Proposed Jacket Foundation Project Option 1

Proposed Jacket Foundation Project Option 2

SITE: NISA		Building 3400 Avenue 3000 Cork Airport Business Park, Cork T12 AE76	NISA North Irish Sea Array	STATUS: PLANNING	
TITLE: Proposed Project Option 1 and Option 2 Side Elevation Comparison				REV:	DESCRIPTION:
SCALE AT A1: 1:1000	DATE: 10/02/2026	DRAWN: EG	CHECKED: JDUB	Approved: MJ	A Issue for Approval JD 8/3/24
					B Issue for Review JD 19/3/24
					C Planning Issue JD 12/4/24
					D Planning Issue RFI EG 10/2/26
					Drawing No: 281240-NISA-OFS-OA-DR-PL-2006

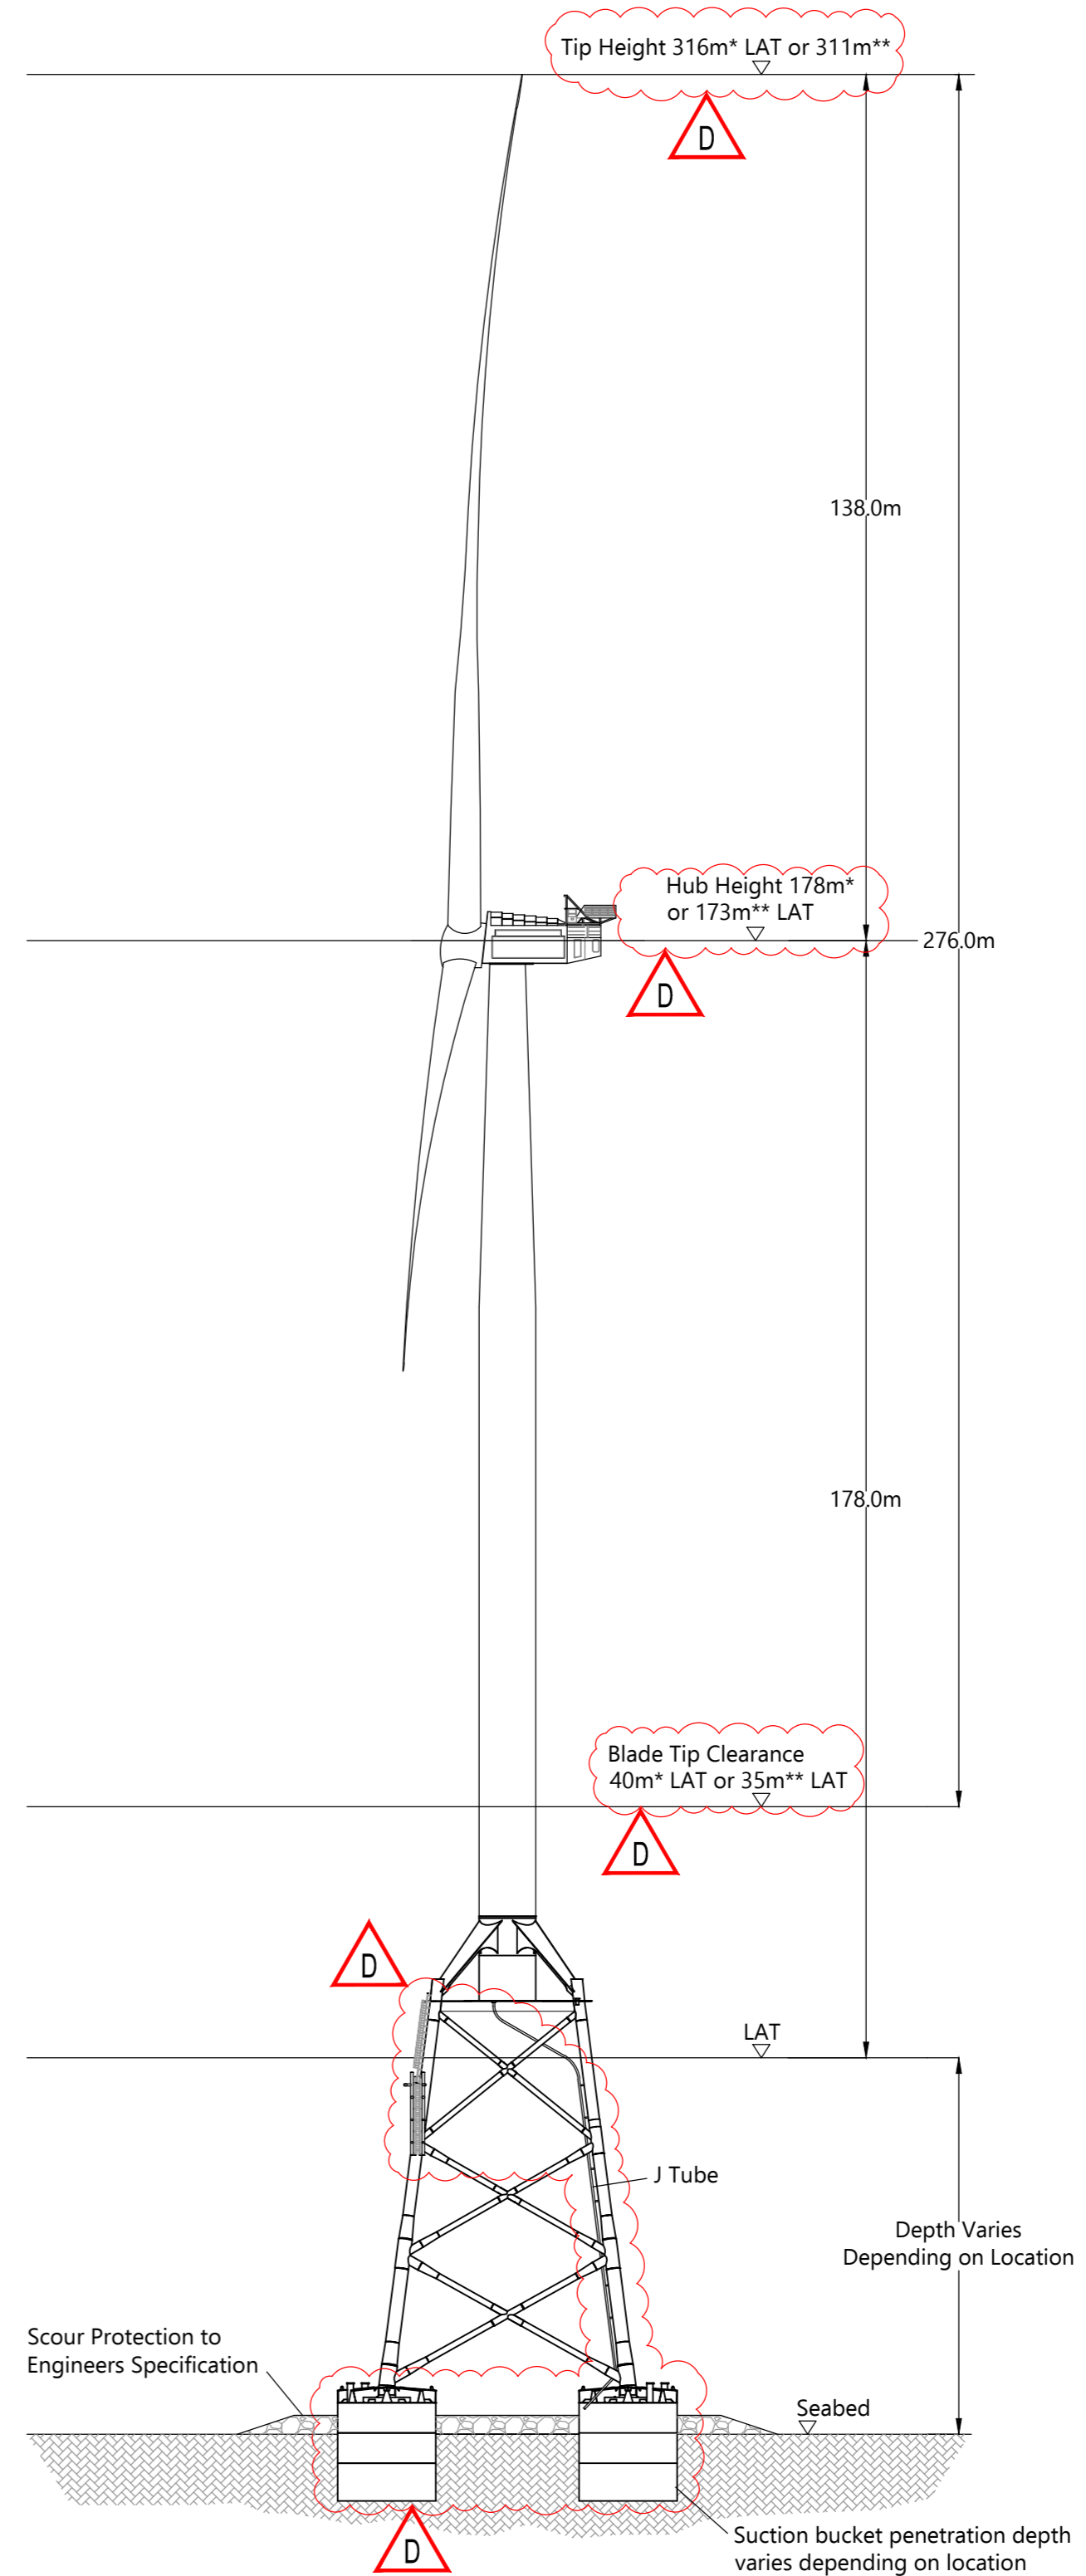
In response to Section 10 (a) of the RFI the Developer has proposed a refinement to the foundation types used for the wind turbine generators (WTGs) and offshore substation platform (OSP). Instead of either monopiles or jackets, only jackets will be used. Additionally, instead of installation with pin piles the jackets will be installed with suction buckets only for WTGs, and either jackets with suction buckets or jackets with drilled pin piles will be used for the OSP.

The Developer notes an administrative error in the planning drawings submitted alongside the 2024 EIAR that did not include the J-tube in the elevation drawings for the jacket foundations. This has now been included to illustrate where the array cables will connect the WTG and OSP to the seabed.
